Groundwater Transfer Review Summary Form

Transfer/PA # T- 14162

Application: T-14162

Applicant Name: Hickey Organics

T-14162**Theis Time-Distance Drawdown**

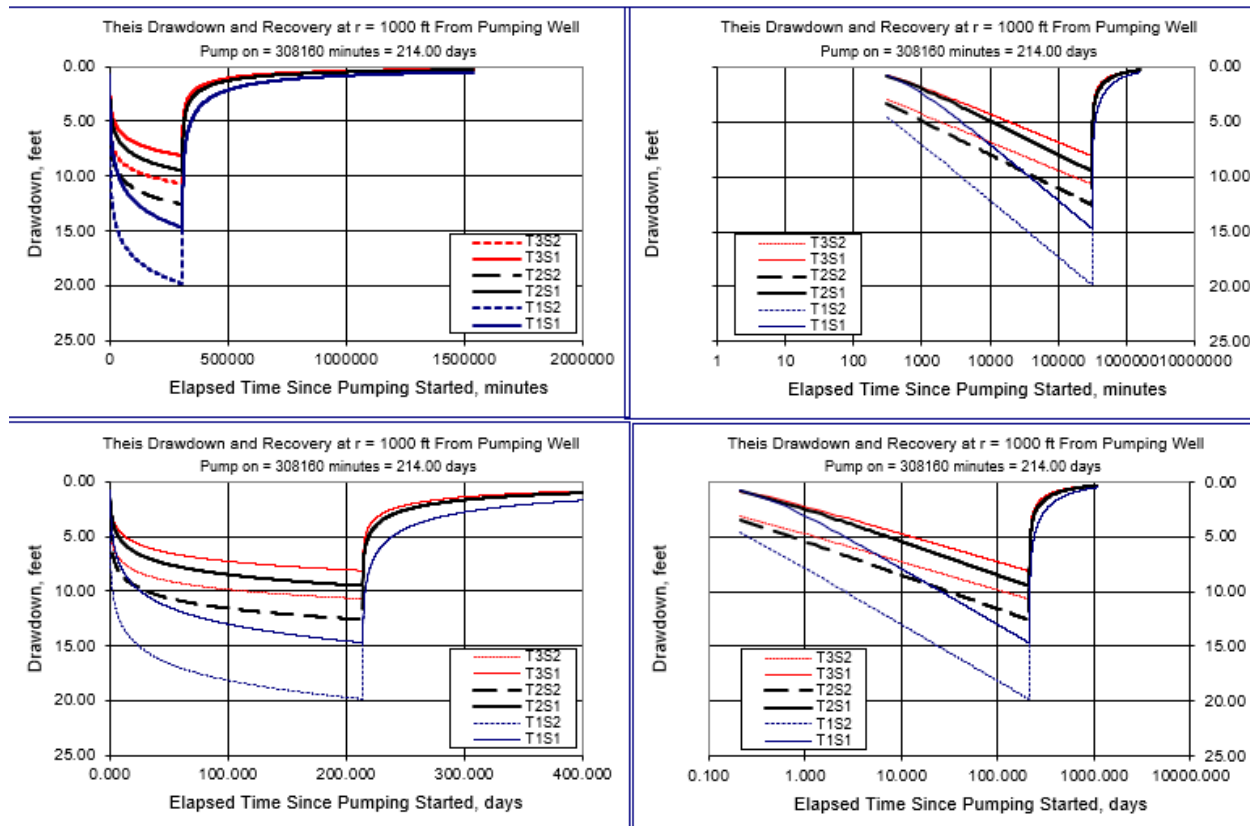
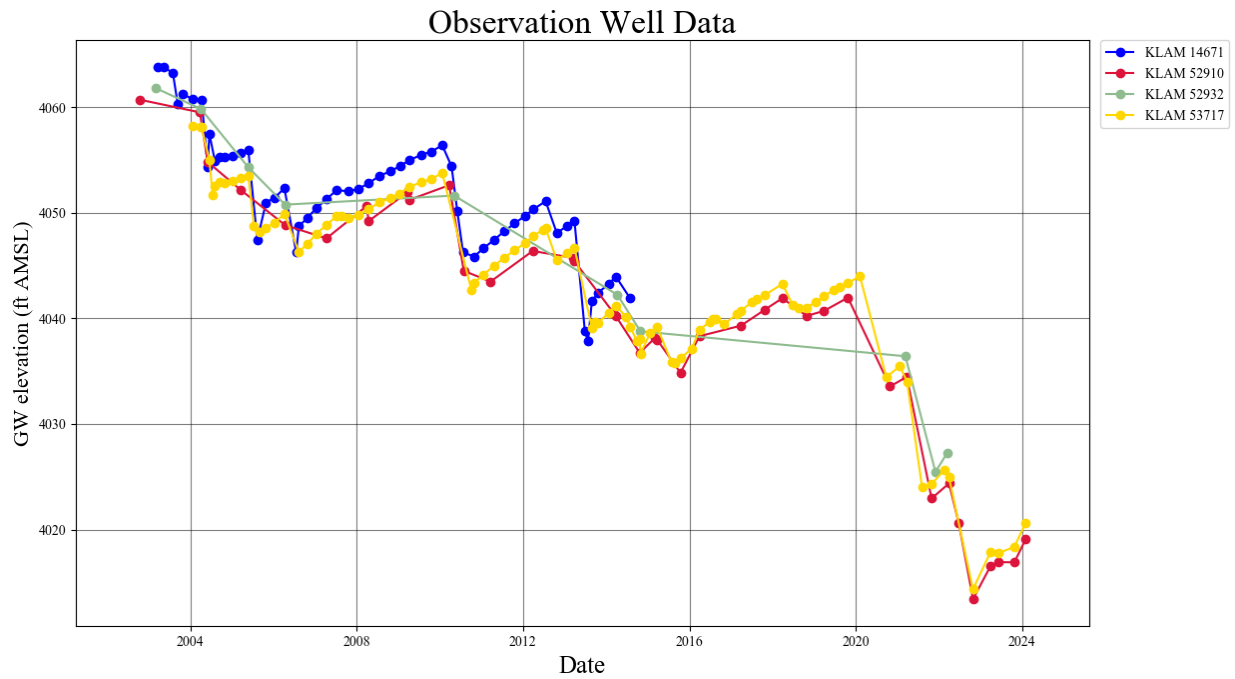
- b) If yes, would this proposed change, at its maximum allowed rate of use, likely result in another groundwater right not receiving the water to which it is legally entitled?
☐ Yes ☒ No If yes, explain: A Theis Time-Distance drawdown analysis was used to estimate the potential drawdown that would be observed in a well 1,000 feet away from the proposed POA at the maximum allowable rate ($389.5 \text{ acres} * 1/80 \text{ cfs/ac} = 4.87 \text{ cfs}$) for the duration of the irrigation season (214 days). Results indicate that use from the proposed POA would cause up to 20 feet of estimated drawdown over the course of the irrigation season when compared to up to 15 feet of estimated drawdown if that use was to remain at the authorized POA (see attached Theis analysis). Due to the generally high-transmissivity and thickness of the aquifer it is unlikely that the proposed change at the maximum allowed rate of use would result in a nearby reasonably efficient well that fully penetrates the aquifer not receiving the water to which it is legally entitled to.
